Subject: Response to DMS comments on the Year 3 Monitoring Report Review for the Upper Silver Creek Stream and Wetland Restoration Project; Catawba River Basin - CU# 03050101; Burke County, North Carolina; NCEEP Project # 94645; Contract No. 003270

Upper Silver Creek Restoration Project Year 3 Monitoring Report

Burke County, North Carolina
NCDMS Project ID Number – 94645

Monitoring Year 3 Profile of UT2, Station 0+00 to 3+20
Data collected October, 2017

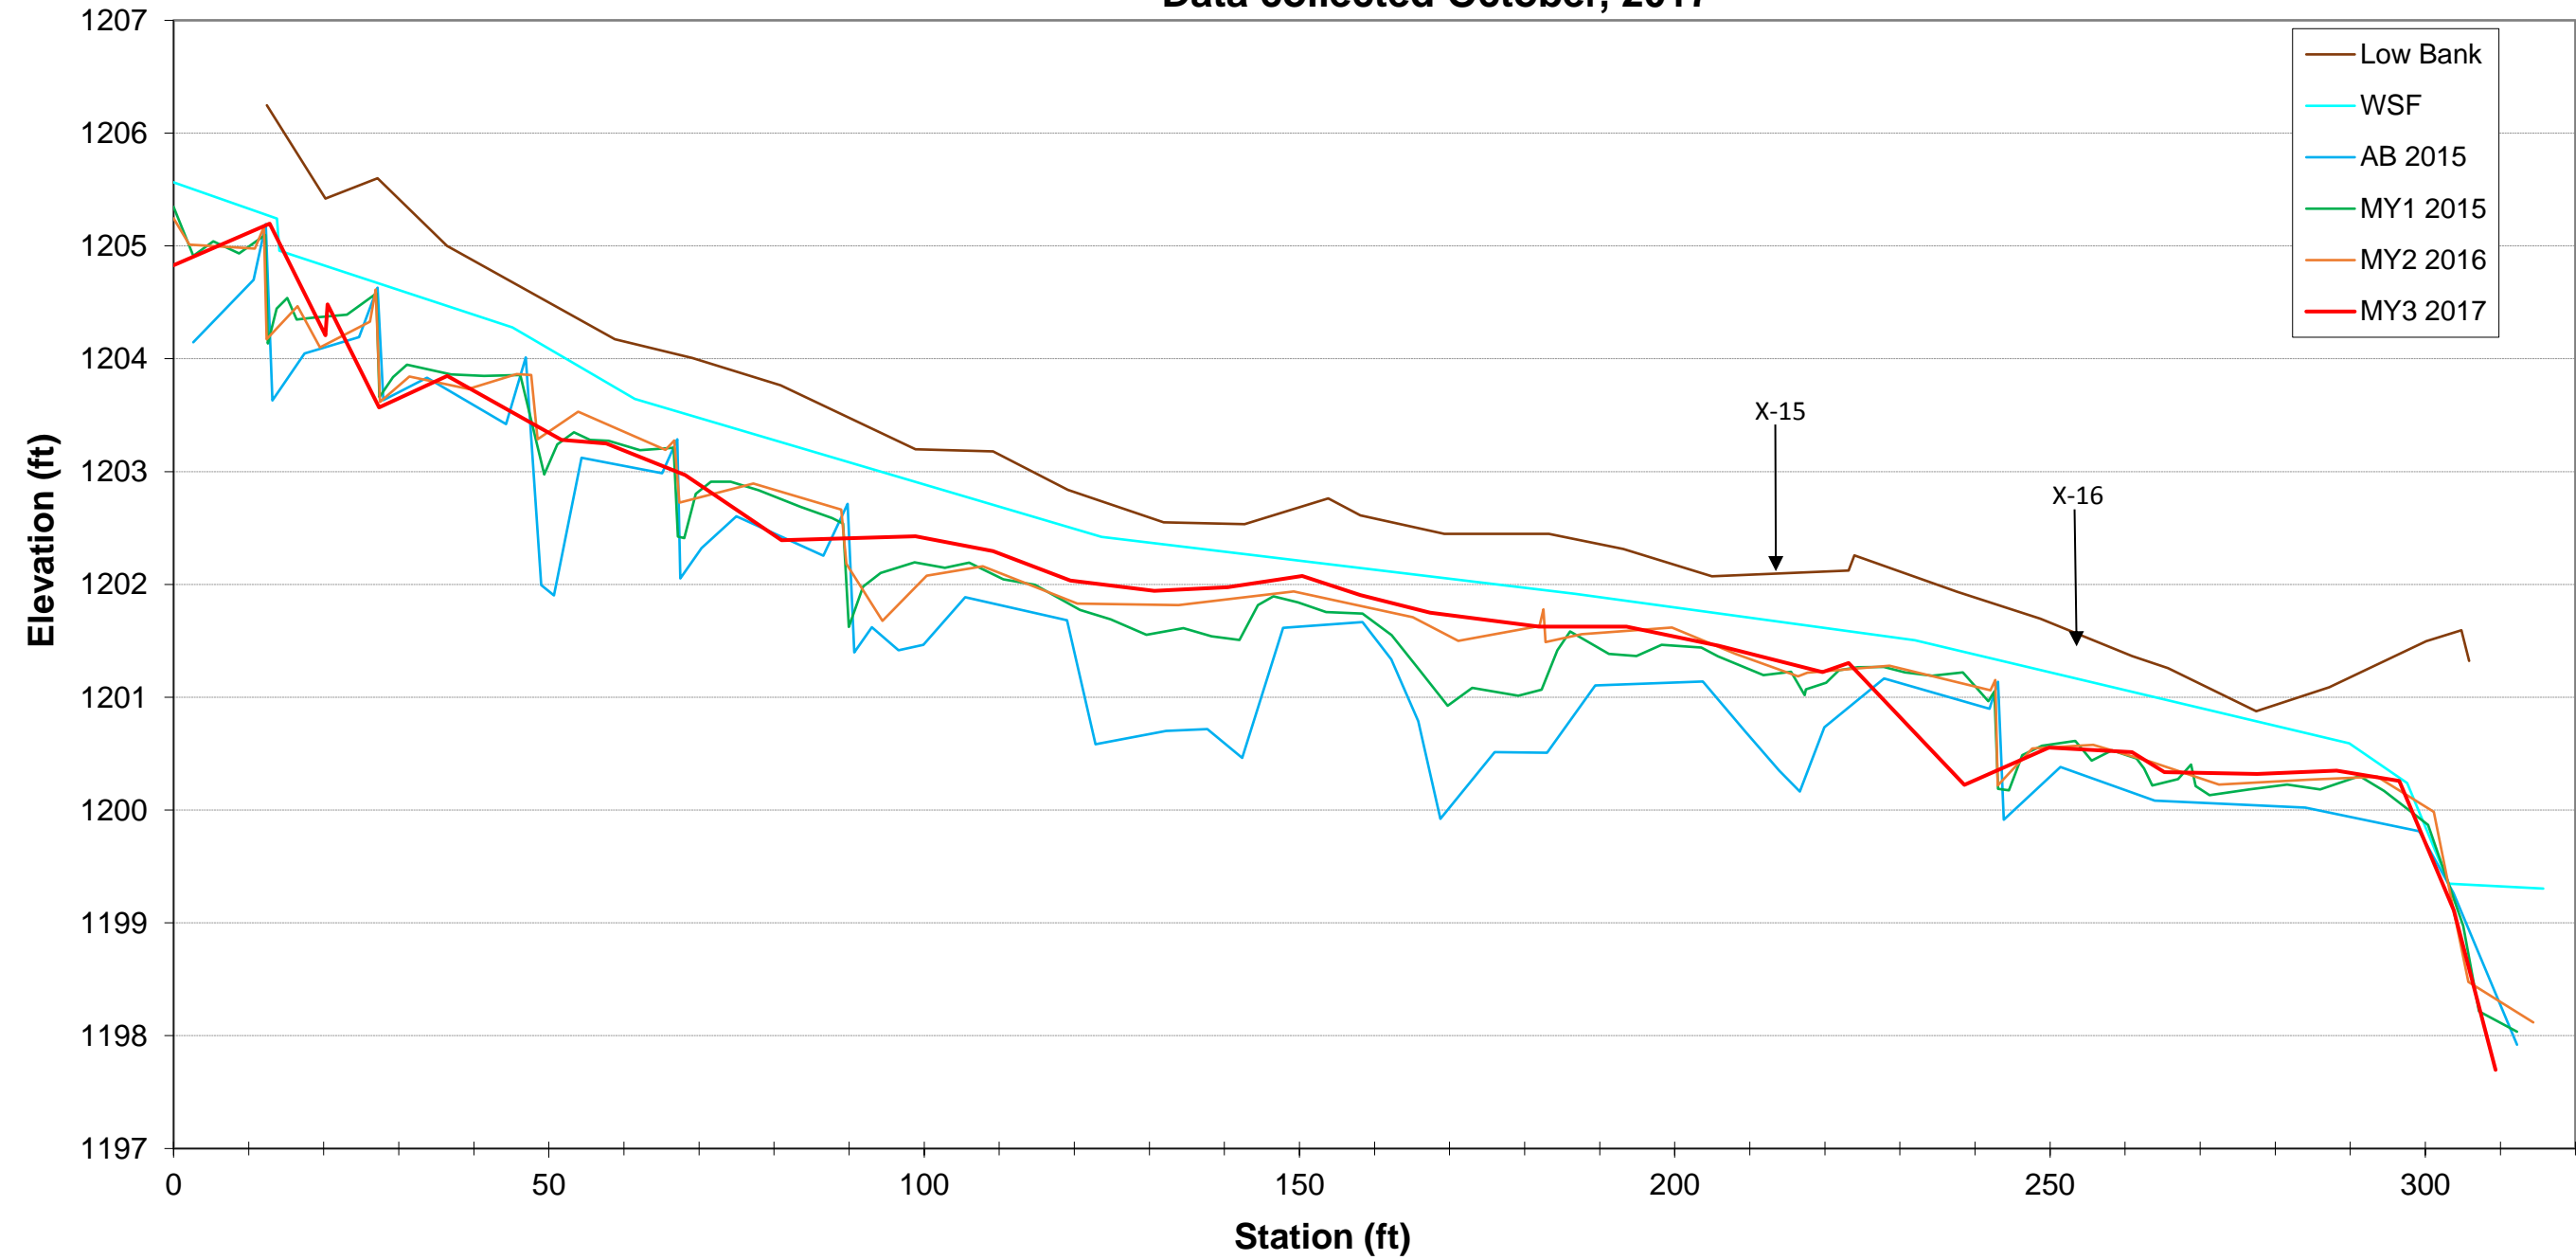
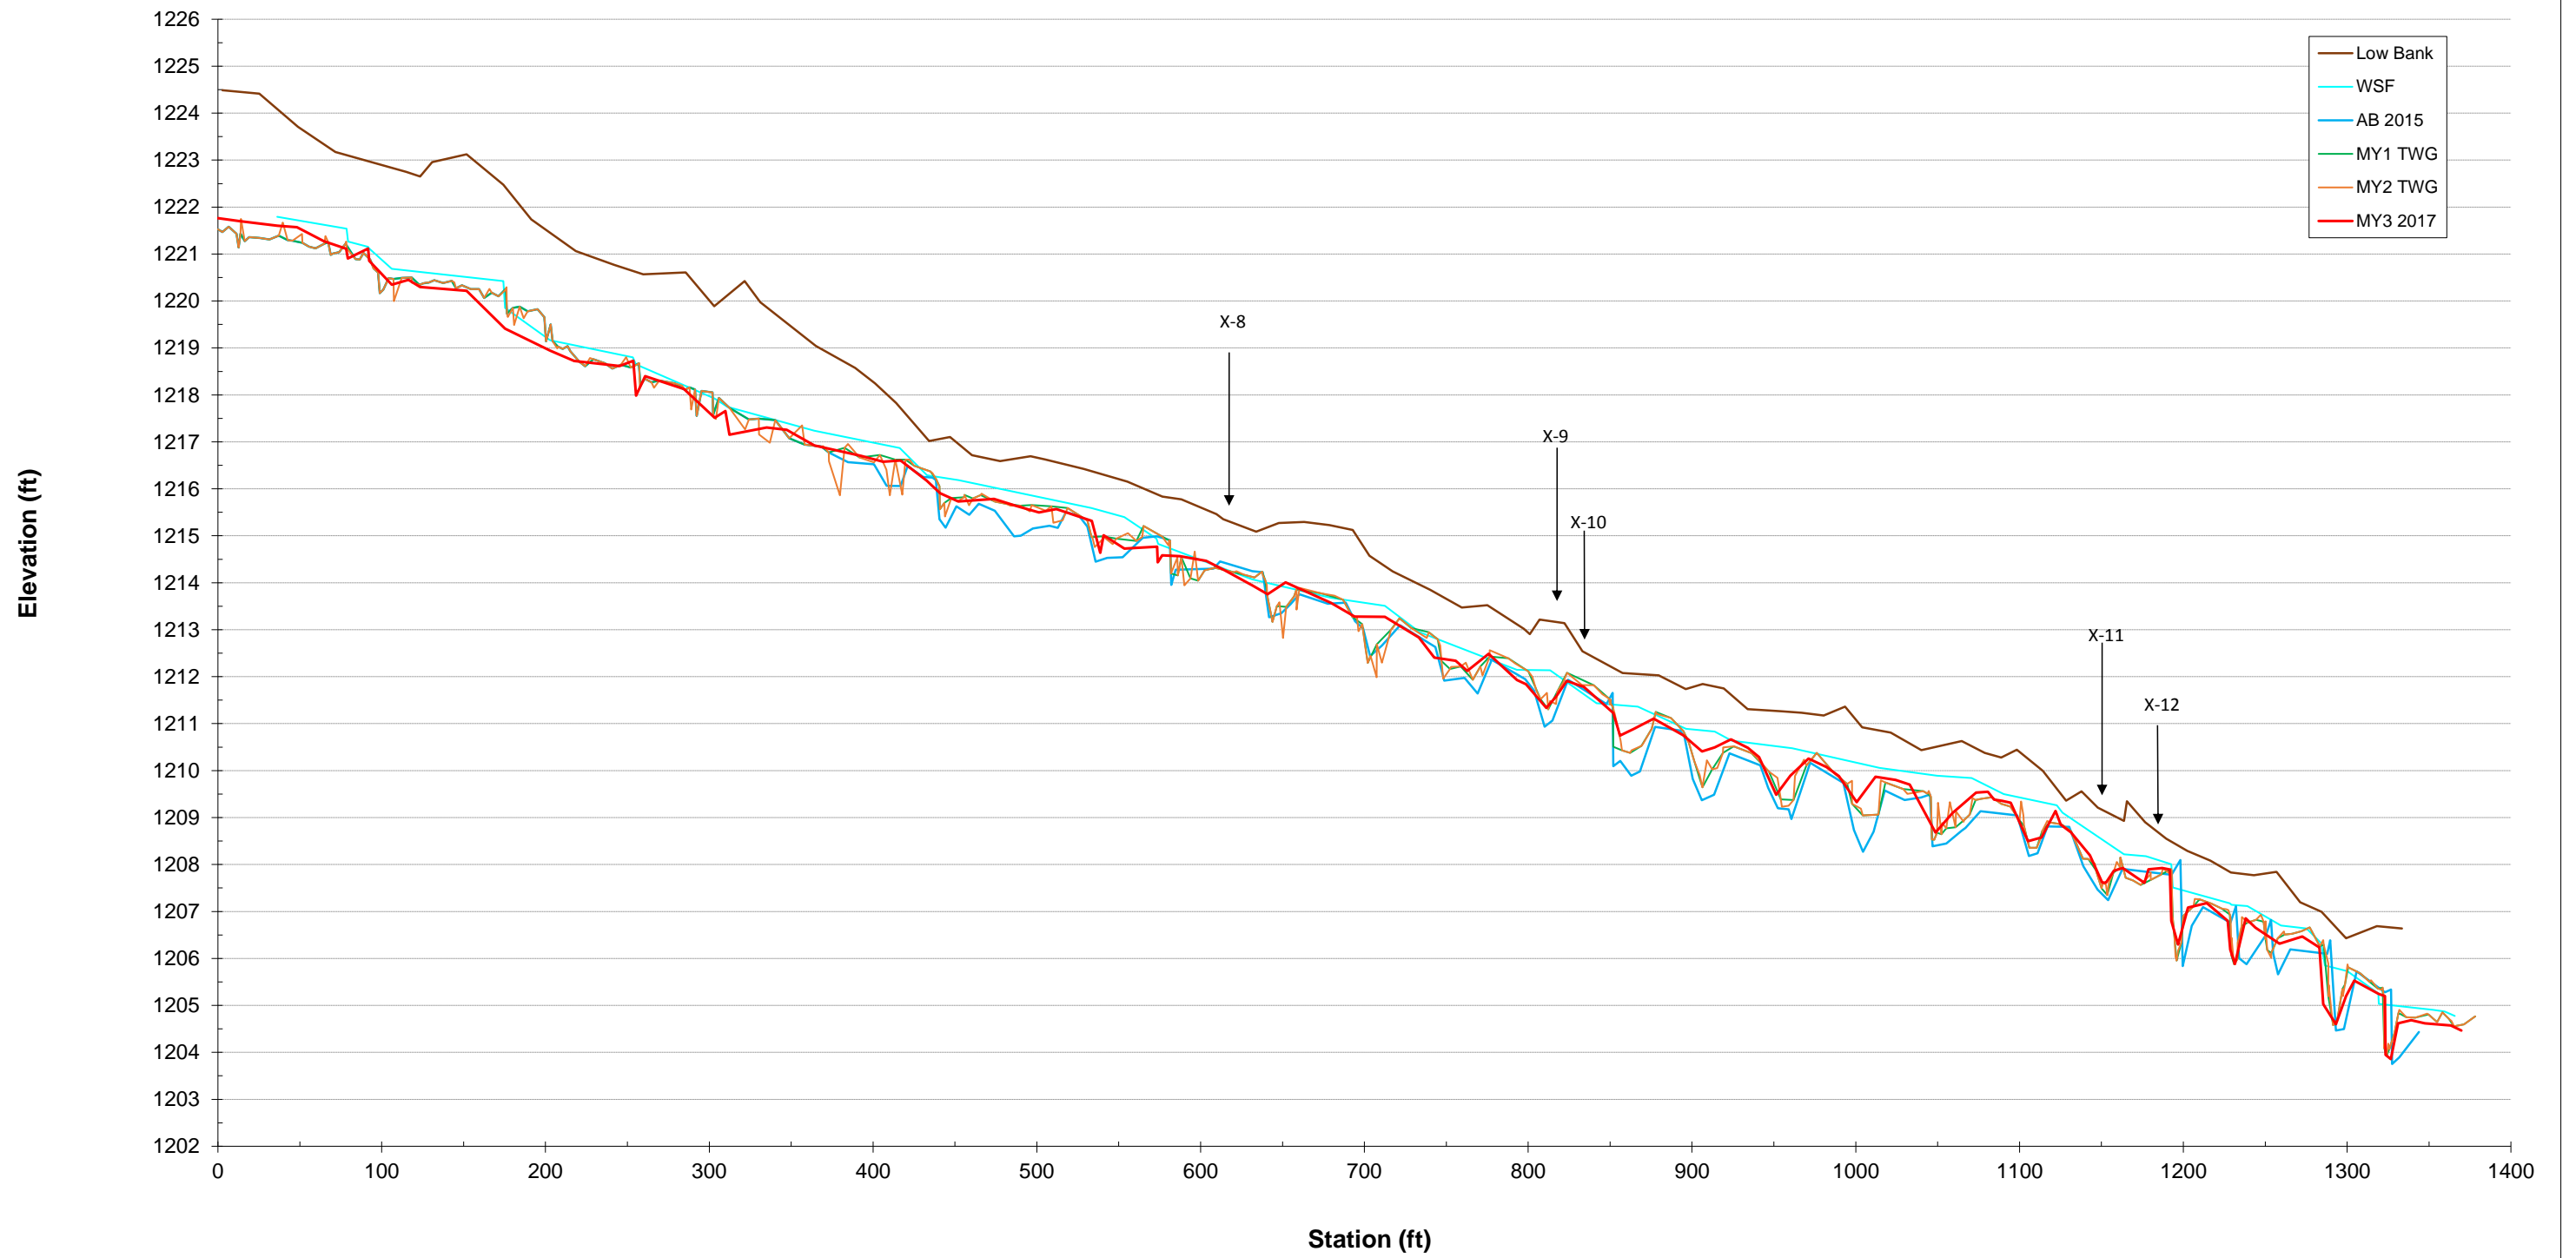
- The UT2 profile and sections of UT3 indicates significant aggradation. As Baker is aware, the USACE will be looking at defined bed/bank and often denies credit for channels that have become filled with sediment. I am aware of the large upstream sediment sources from past mining activities on UT2. Does Baker have any corrective action or adaptive management planned for these?
 - *No corrective actions are planned for the upcoming year. These sections of UT2 and UT3 will be monitored throughout the winter to see if high seasonal flows clear any of the deposited sediment from the channels and reevaluated in MY4.*
